PIC32MZ Embedded Connectivity with Floating Point Unit (EF) Family Silicon Errata and Data Sheet Clarification

The PIC32MZ Embedded Connectivity with Floating Point Unit (EF) family of devices that you have received conform functionally to the current Device Data Sheet (DS60001320G), except for the anomalies described in this document.

FIGURE 1: Posc CRYSTAL CIRCUIT

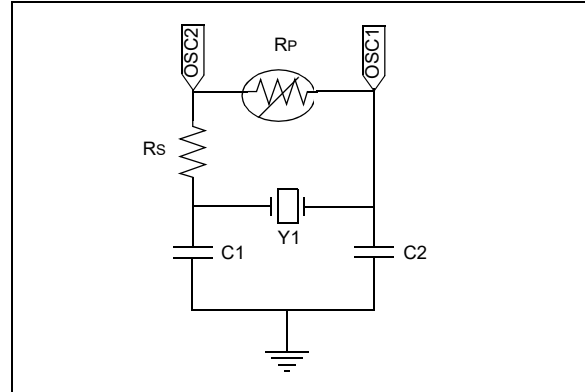
Revision A1 Silicon: A crystal oscillator cannot be used as an input to the Primary Oscillator (Posc) pins OSC1 and OSC2.

Revision A3 and B2 Silicon: The Posc has been tested in a normal power-up sequence and supports specific crystal operation.

The Primary Oscillator (Posc) has been characterized to operate at 8 MHz, 12 MHz, and 24 MHz when the circuit in [Figure 1](#) is implemented, and the operating conditions listed in [Table 3](#) are met.

Crystal Frequency (see Note 1)	Series Resistor (Rs)	Posc Gain Setting POSCGAIN<1:0> (DEVCFG0<20:19>)	Posc Boost Setting POSCBOOST (DEVCFG0<21>)
8 MHz	2 kΩ	'0b00 (GAIN_0)	'0b1 (ON)
12 MHz	1 kΩ	'0b00 (GAIN_0)	'0b1 (ON)
24 MHz	0 kΩ	'0b00 (GAIN_0)	'0b1 (ON)

- Note 1:** Using any other crystal frequency will require special component selection and characterization.
- Note 2:** A parallel resistor (Rp) should not be used to increase the gain of the POSC.
